1 Redline Revision
Dated October 3, 2011

MD 188 (WILSON LANE) AND WHITTIER BLVD

TRAFFIC SIGNAL PLAN

TS NO. 40E | DRAWING NO. 1 OF 3 | SHEET NO. OF

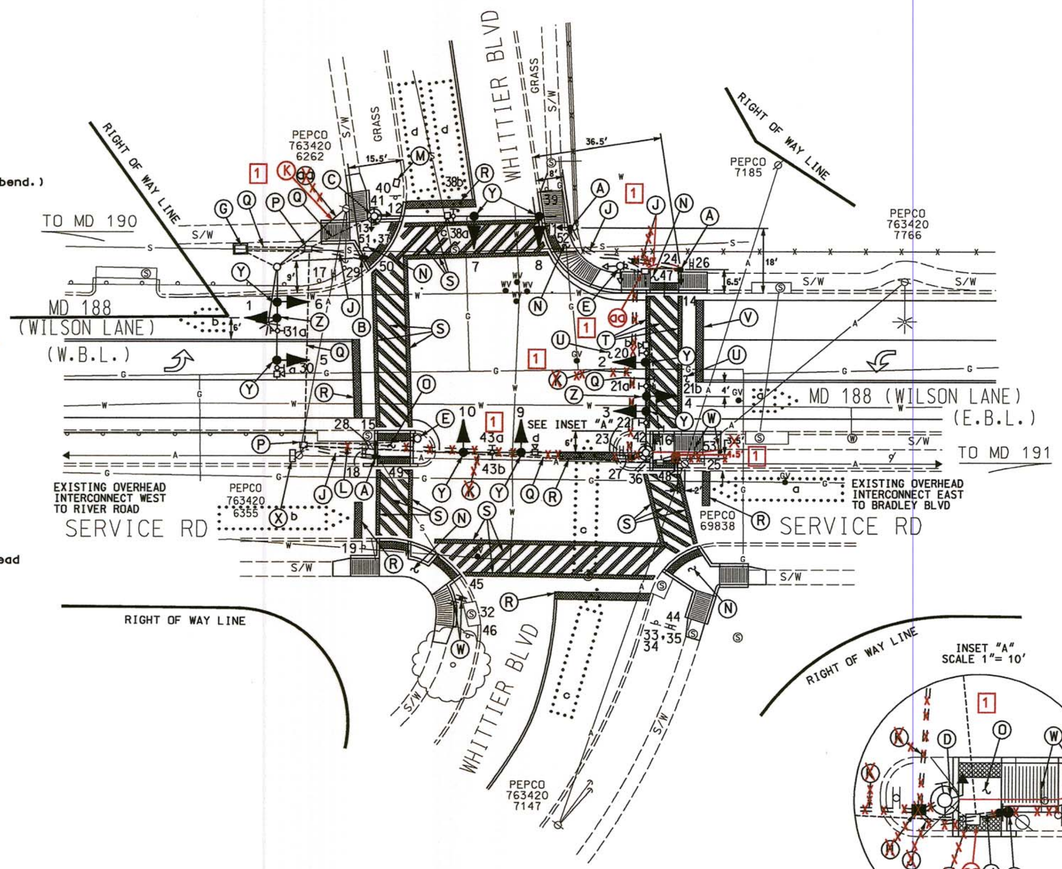
1 D. Remove existing pedestrian signal head, pushbutton and pedestrian education sign. Plug pushbutton hole. Install Countdown pedestrian signal head as shown. ~~(Note: Contractor shall install 3" bend into existing signal pole foundation. Disconnect existing traffic signal and video camera cables on both mast arms from the controller and pull back to the pole base. Signal heads and video detection cameras wiring shall be rerouted thru new conduit. See Wiring Diagram on Sheet 3 of 3).~~

1 K. ~~Install 4" polyvinyl chloride electrical conduit (Schedule 80) (slotted).~~ Existing overhead electrical service to be maintained by PEPCO.

1 aa. Use existing handhole, adjust to grade of slope as needed.
